Lack of Maintenance Reminder in MID

YEAR(S)	MODEL(S)	ADDITIONAL INFORMATION
2023	bZ4X

Introduction

Figure 1. Maintenance Reminder Messages on MID in Combination Meter Assembly

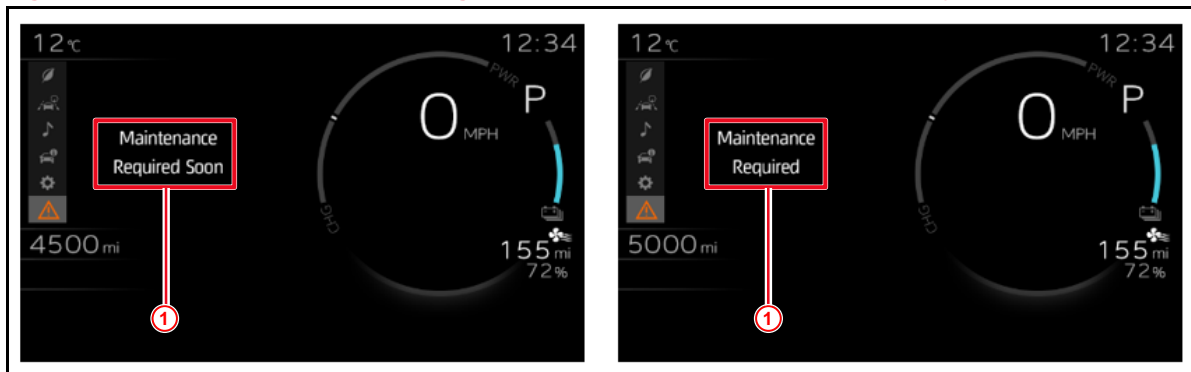
Some 2023 model year bZ4X vehicles may exhibit a condition in which the maintenance reminder messages (Figure 1) do not display on the multi-information display (MID) in the combination meter at scheduled maintenance intervals. The combination meter ECU has been updated to address this condition. Follow the Repair Procedure in this bulletin to reprogram the combination meter ECU.

NOTE
When the condition occurs, maintenance messages do not display on the combination meter.

1. Confirm the condition exists.
 - A. Are maintenance reminder messages displayed on the MID in the combination meter at scheduled maintenance intervals as shown in Figure 1 in the Introduction?
 - **YES** — This bulletin does NOT apply. Continue diagnosis using the applicable Repair Manual.
 - **NO** — Continue to substep B.
 - B. Confirm the combination meter calibration.
 - (1) Use Techstream to check the current combination meter ECU Cal ID.
 - (2) Is the calibration ID of the combination meter listed in Techstream as shown in the Previous column of the Calibration Information table above?
 - **YES** — Continue to step 2.
 - **NO** — This bulletin does NOT apply. Continue diagnosis using the applicable Repair Manual.
2. Reflash the combination meter ECU.
